November 12, 2015

Re: COPC Mapping White Paper – CPG Response — May 2007 Administrative Agreement and Order on Consent for Remedial Investigation/Feasibility Study – CERCLA Docket No. 02-2007-2009 (AOC)

RESPONSE TO REGION 2 WHITE PAPER ON CONTAMINANT MAPPING

LOWER PASSAIC RIVER STUDY AREA REMEDIAL INVESTIGATION/ FEASIBILITY STUDY

Figure 3-4
Extent of RM10.9 Design Data within Region 2 Analysis Extent
Contaminant Mapping Response
Lower Passaic River Study Area Remedial Investigation/Feasibility Study

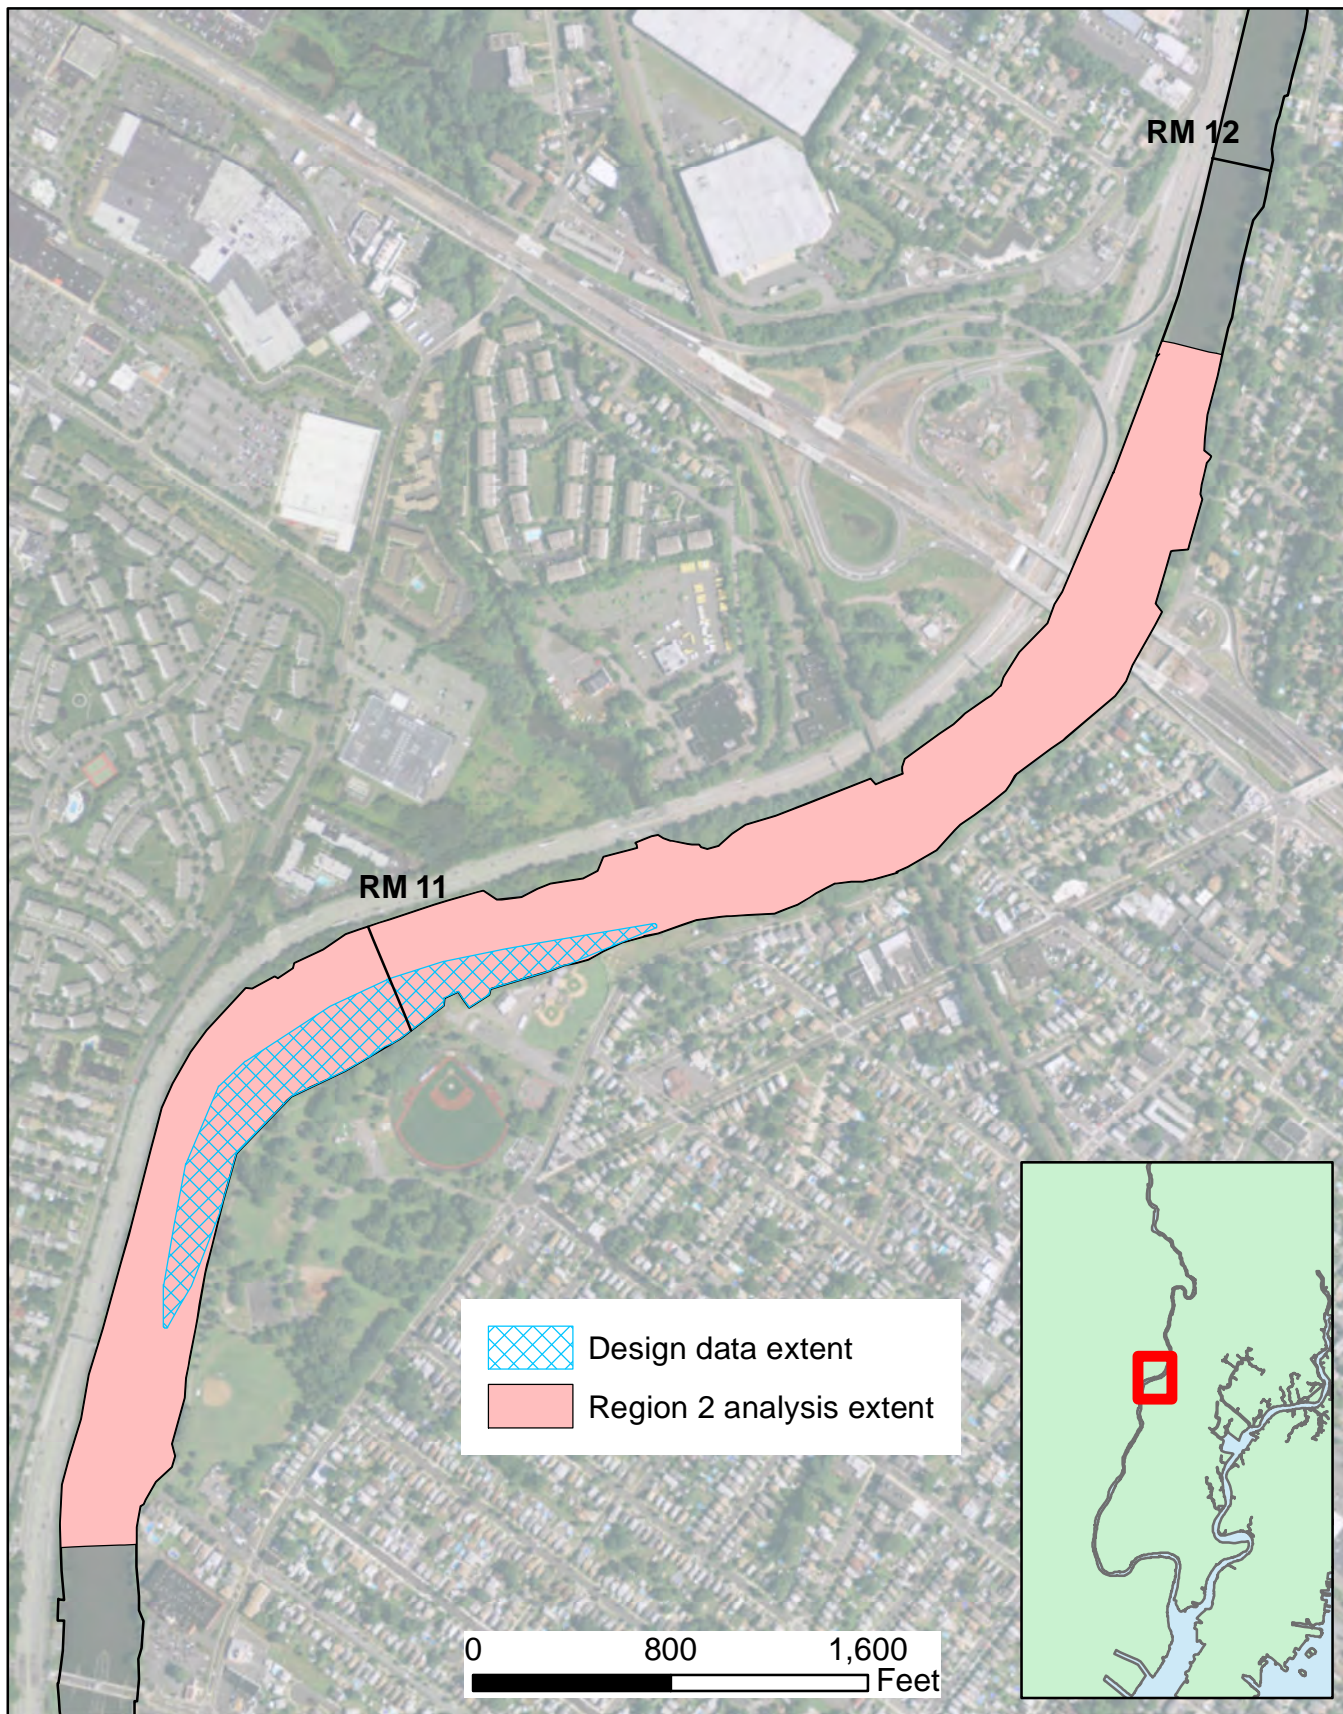
Two aspects of Region 2's test invalidate its conclusions: 1) it considers an area that extends far beyond the region where design scale data exist (Figure 3-4); and 2) it does not test the map presented in the Draft 17-mile RI Report; rather it tests a cruder map generated using only a portion of the RI data.

Figure 3-5
Comparison of RI-dataset Used by Region 2 With Full RI Dataset Near RM 10.9
Contaminant Mapping Response
Lower Passaic River Study Area Remedial Investigation/Feasibility Study

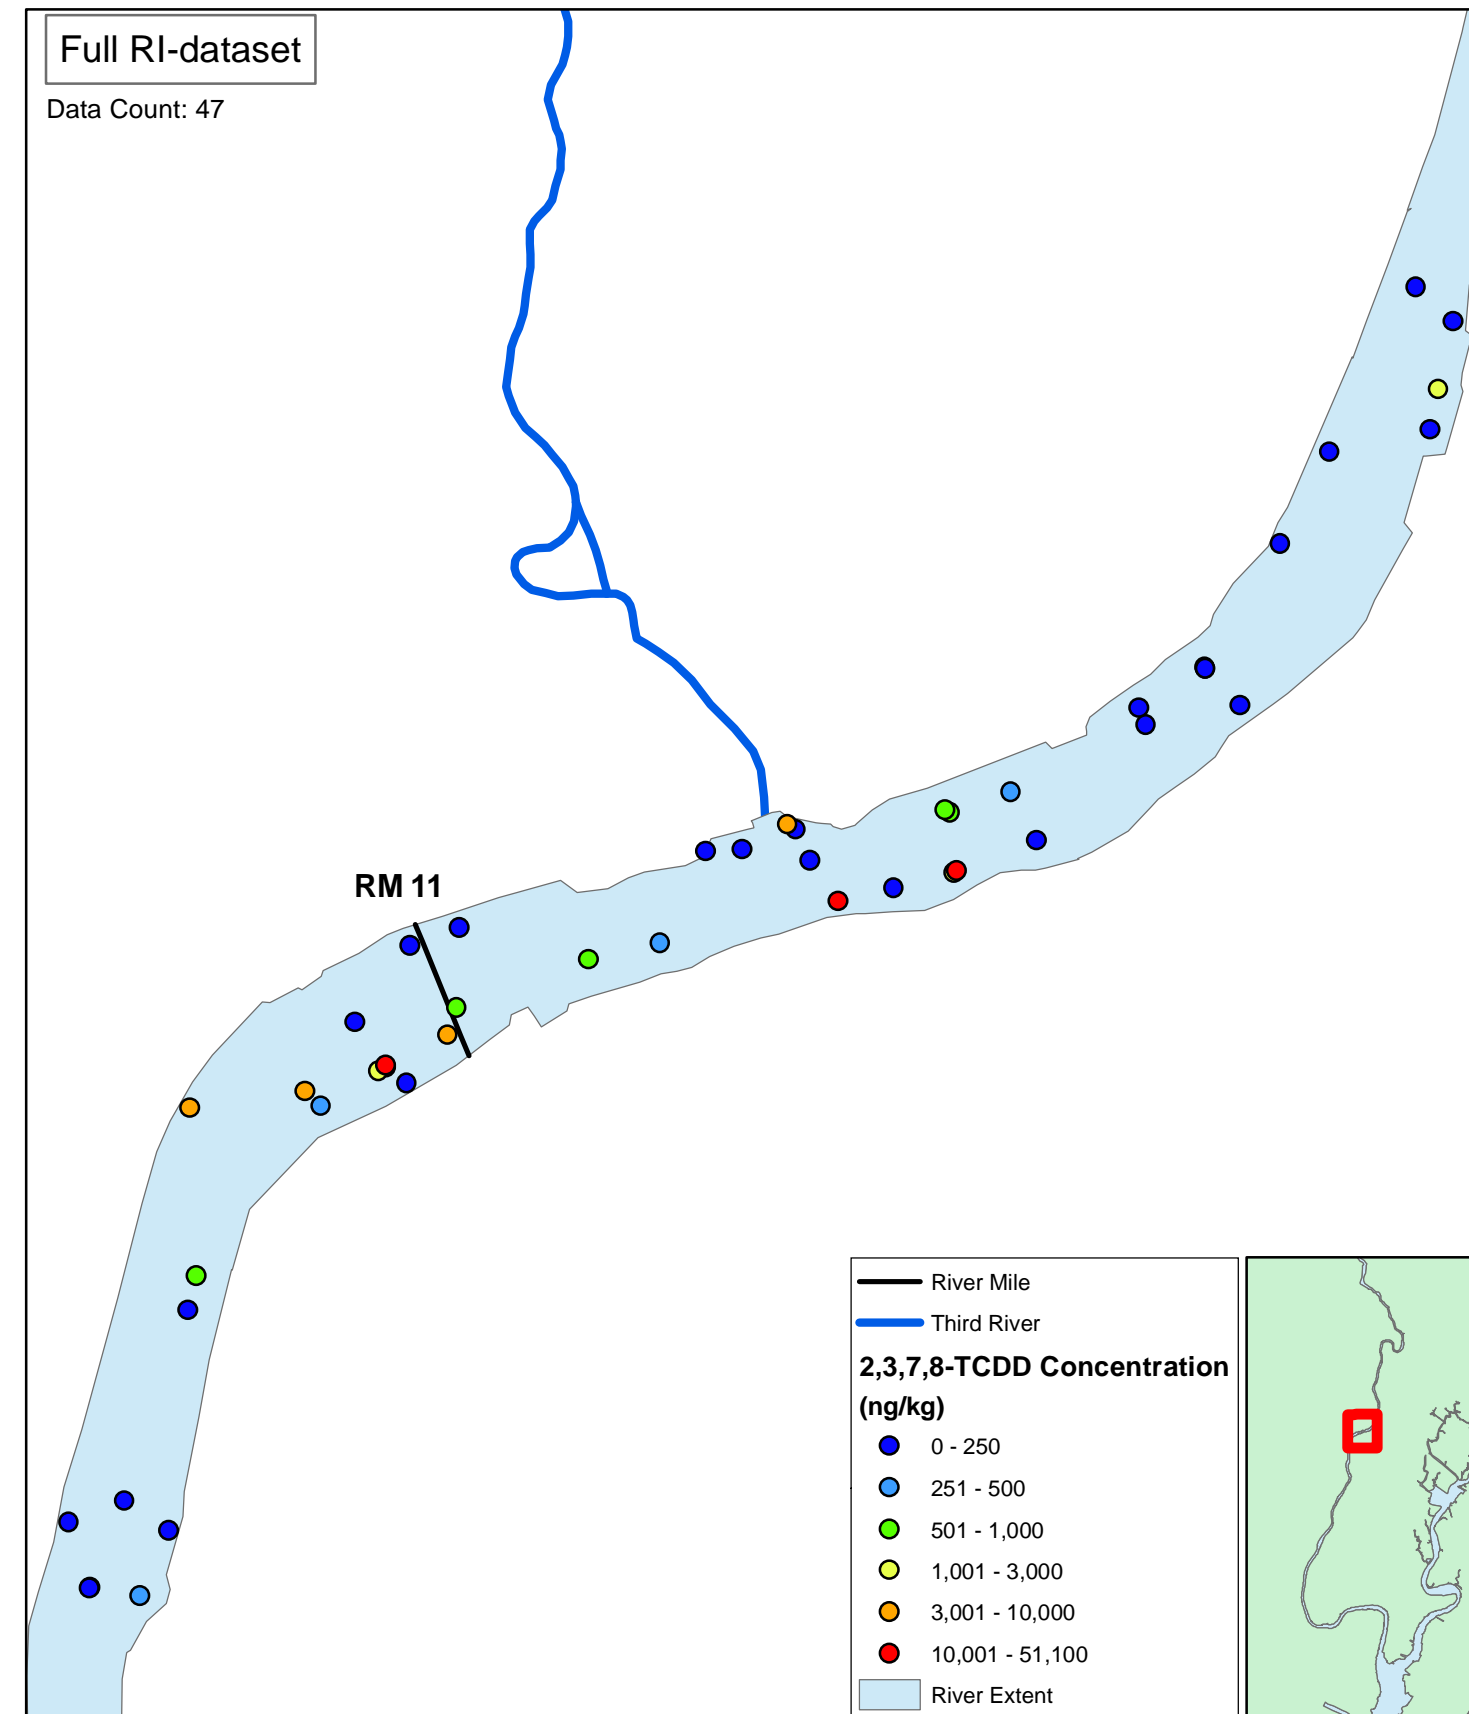
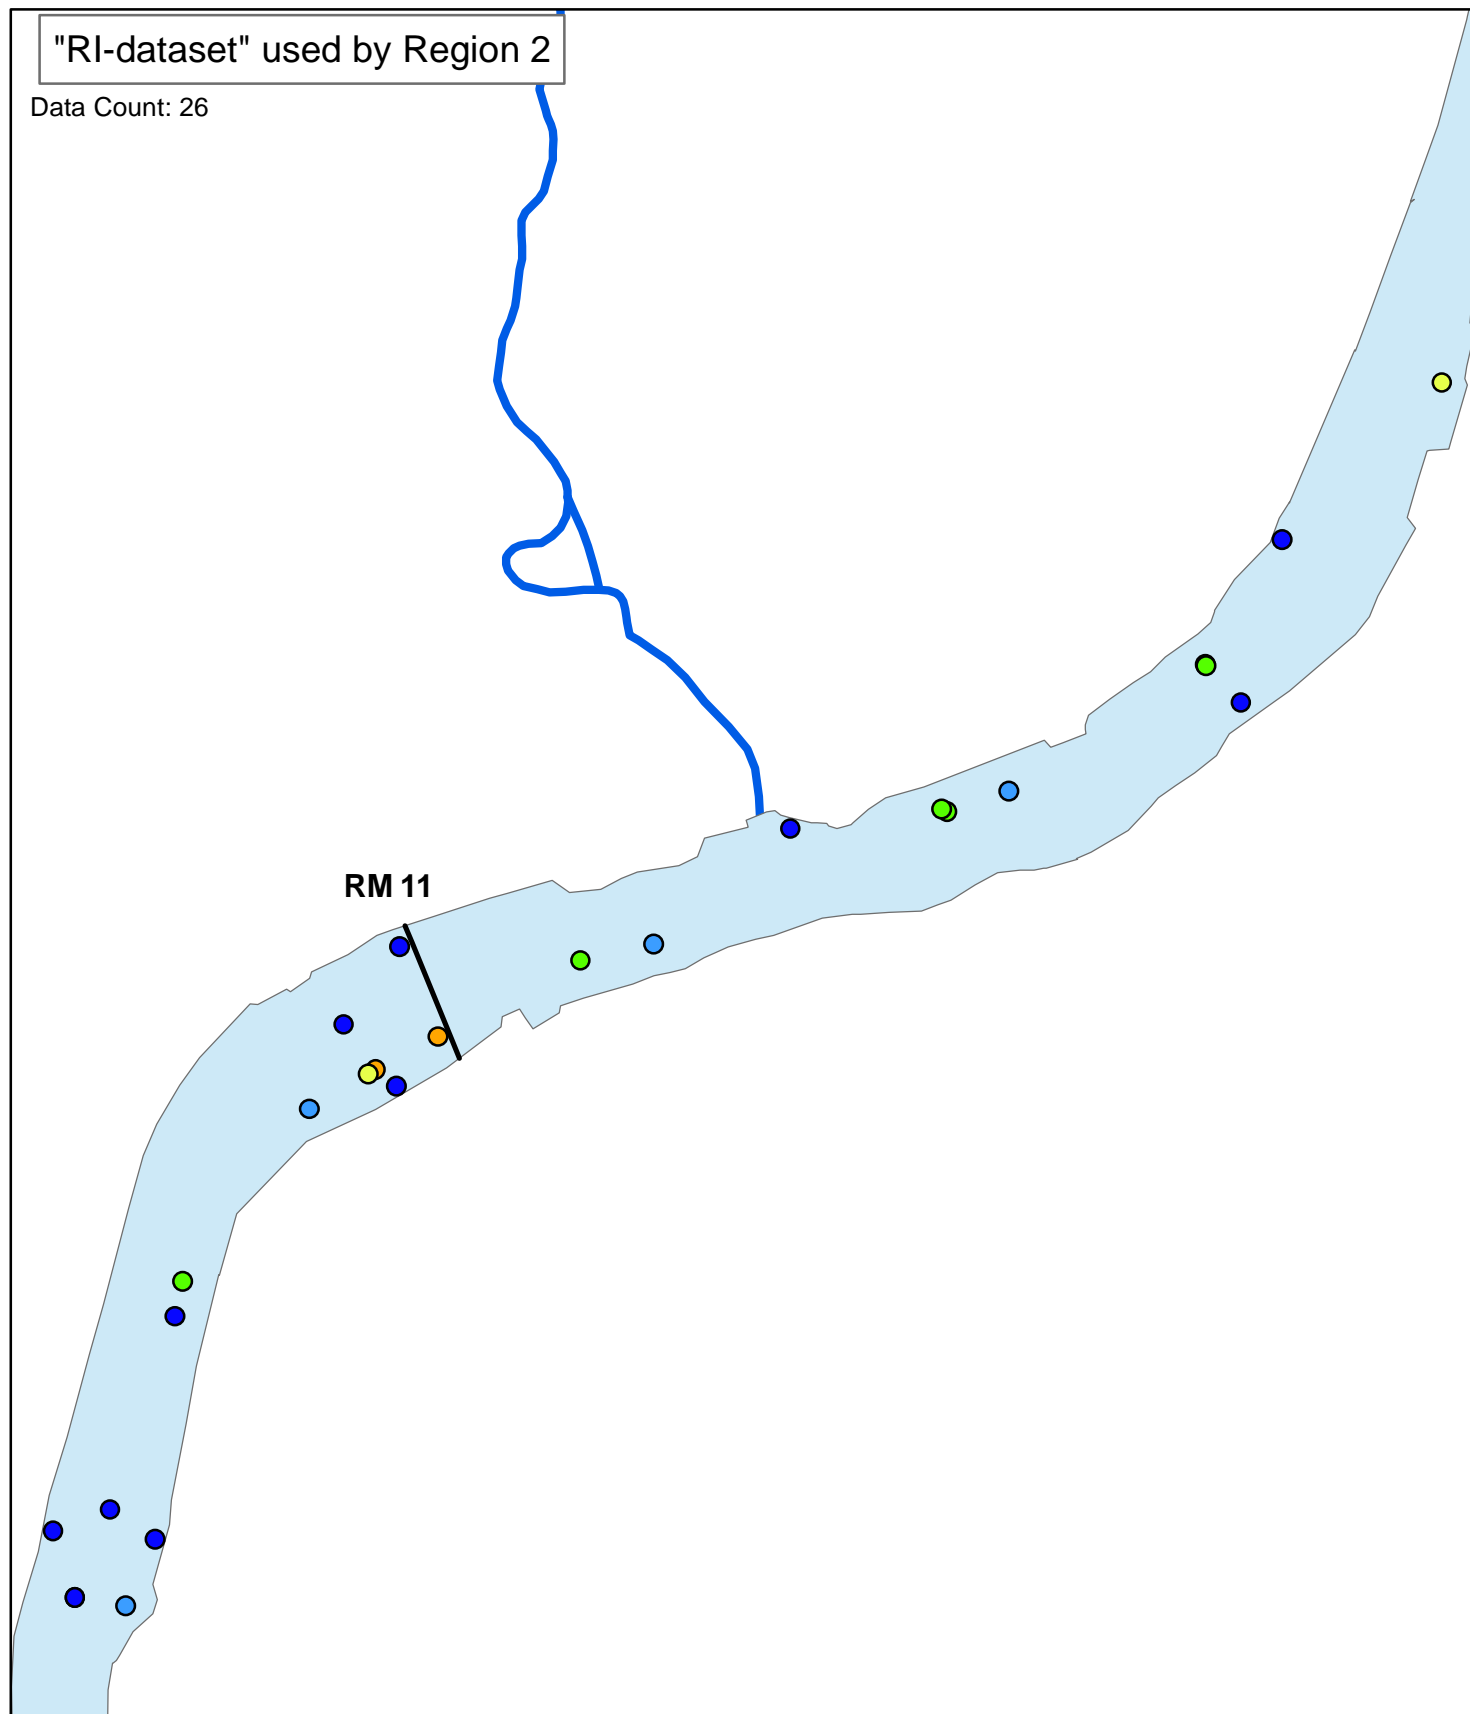
Figure 3-5 shows the supposed "RI-dataset" used by Region 2 (left panel) and the full RI-dataset (excluding the RM 10.9 design data) on the right panel. Note the paucity of data that Region 2 relied on to develop a map to test. It is unclear why Region 2 tested a cruder map instead of one that uses all available RI data in the same manner as the Draft 17-mile RI Report map. The data excluded from the Region 2 map are an important part of the mapping that is critiqued in the White Paper and had been collected to address recognized data gaps. From the start, the exercise was not a well-constructed test of the CPG mapping.

Figure 3-6
Comparison of RI Dataset and RI Dataset with RM 10.9 Design Data Interpolations
Contaminant Mapping Response
Lower Passaic River Study Area Remedial Investigation/Feasibility Study

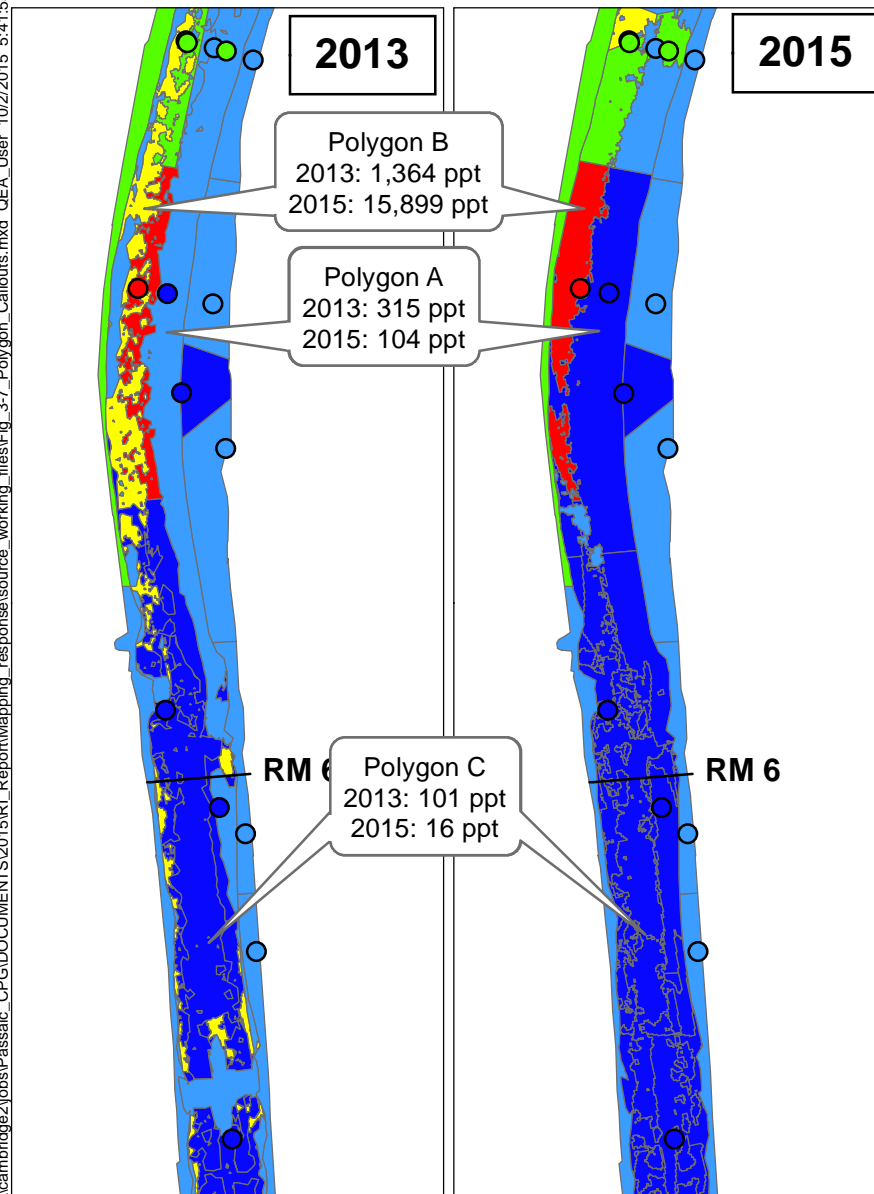
The RI scale and design scale maps are shown in the left and right panels of Figure 3-6, respectively. Remedial footprints were generated using a 500 ng/kg RAL, for each of the two maps separately. Percent reduction in concentration and other parameters derived from the targeted remediation are presented in Table 3-1. The two maps yield the same percent reduction in SWAC of 97%. The design scale map shows a net 1-acre (7.3%) change in the area meeting the RAL, indicating the adequacy of the CPG's FS-level mapping to realistically represent a targeted remedy footprint.

The results of the only rigorous test that can be conducted at this stage show that the CPG method of mapping provides a reasonable basis for crafting targeted remedy alternatives for the FS.

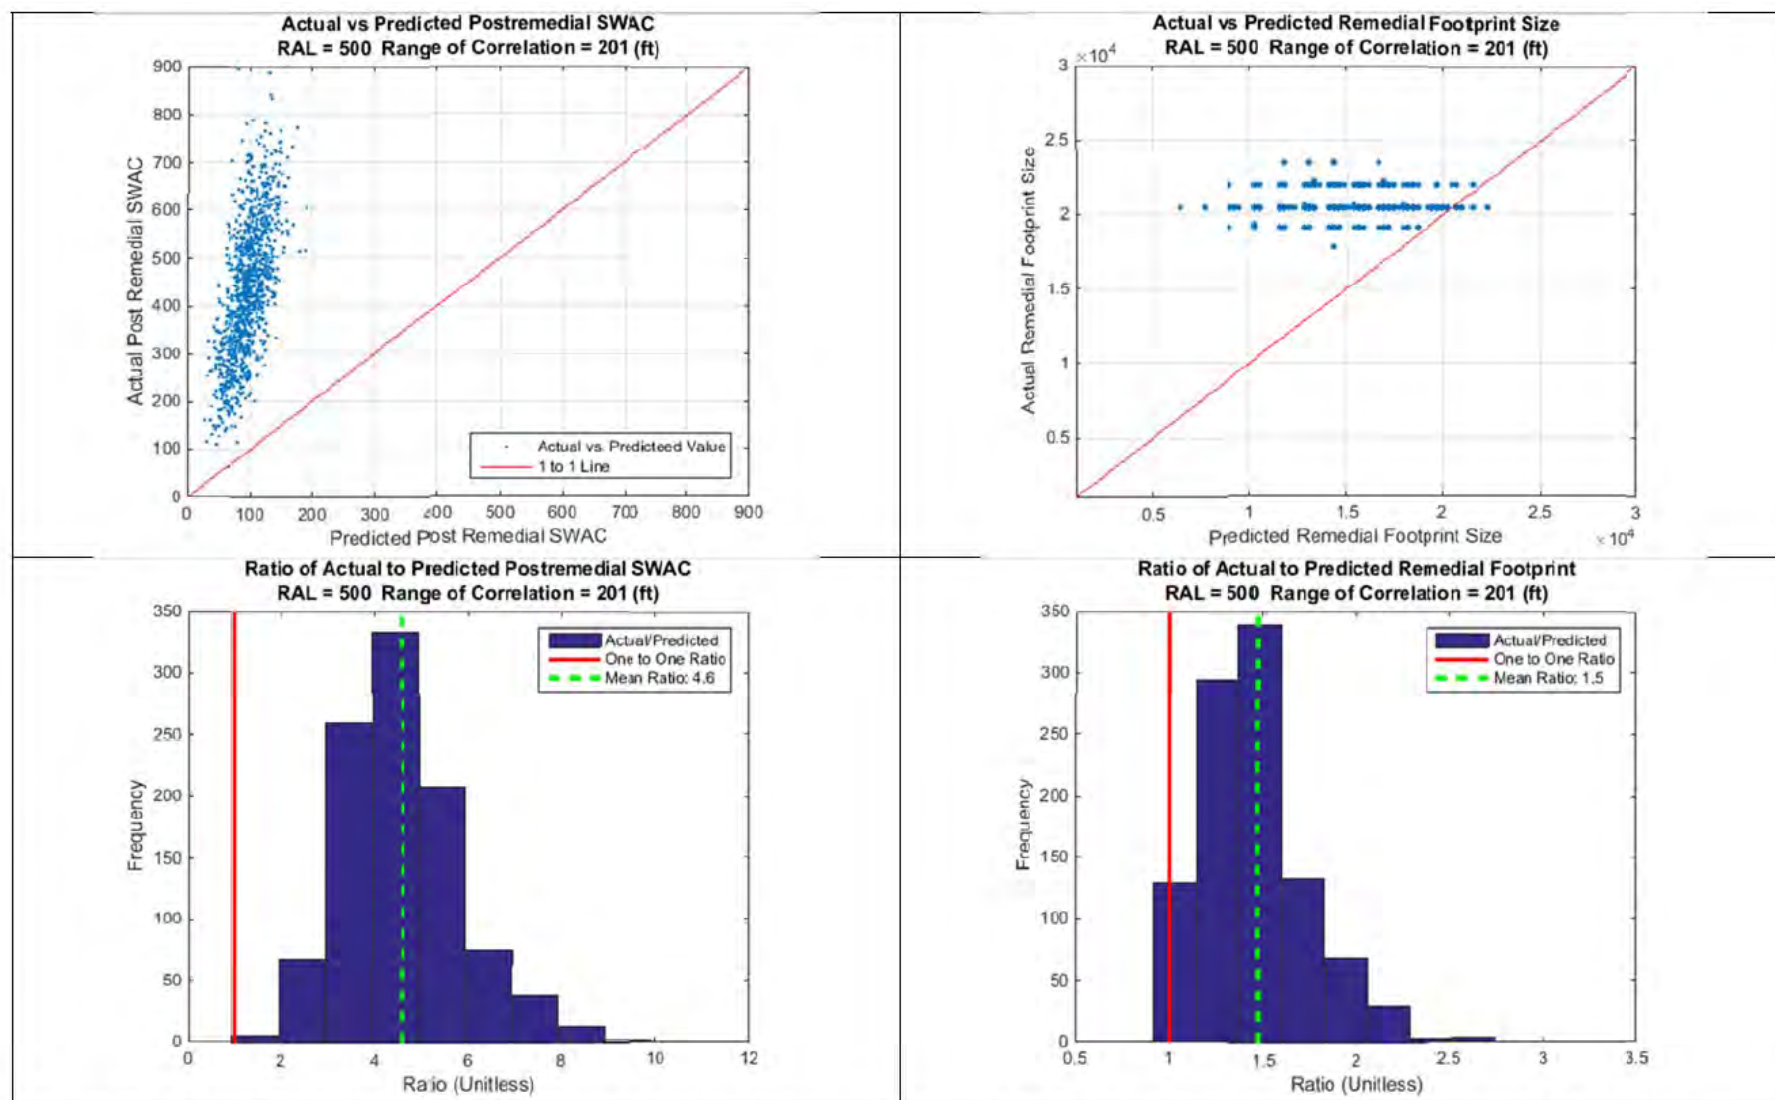
The major conclusions drawn from the simulation study derive from the left panels of Figure 3-10 (Figure 19 from the White Paper), which summarizes the results of conducting the following remedial benefit calculation for each of 1,000 different realizations of the randomized concentration field:

3. Calculate a Predicted Post Remedial SWAC across all decision units using the post-remedial concentrations from Step 2; this quantity is shown on the horizontal axis of the upper left panel of Figure 3-10.

4. Compare this value to an Actual Post Remedial SWAC across all decision units, calculated by repeating Step 3 using instead the actual (or "true") decision unit average concentrations for non-remediated cells; this quantity is shown on the vertical axis of the upper left panel of Figure 3-10.

The choice of the input distribution and the large size of the decision units relative to the correlation length cause the Predicted Average concentration for each decision unit (see Step 1 above) to most often be less than the actual ("true") average, due to the nature of the log-normal input distribution from which the random concentration field was generated (Figure 3-11, showing an example of Region 2's input distributions). The likelihood of picking values at or above the "true" average in a majority of the decision units is vanishingly

small, given the approximate one-in-five chance of doing so in each unit, and consequently the predicted average concentration across all decision units will almost always be lower than the “true” average. In the evaluation of remedial benefit, consistently under-predicting the average of decision units causes some units that should be remediated to not be, thus leaving contaminant mass behind. This behavior gives rise to the result in the left panels of Figure 3-10 that the Predicted Post Remedial SWAC across all decision units is less than the Actual Post Remedial SWAC in 999 of 1,000 simulations. This behavior also causes the targeting of less total area for remediation relative to the area that would have been targeted using the true average of decision units, as shown in the footprint comparisons in the right panels of Figure 3-10.
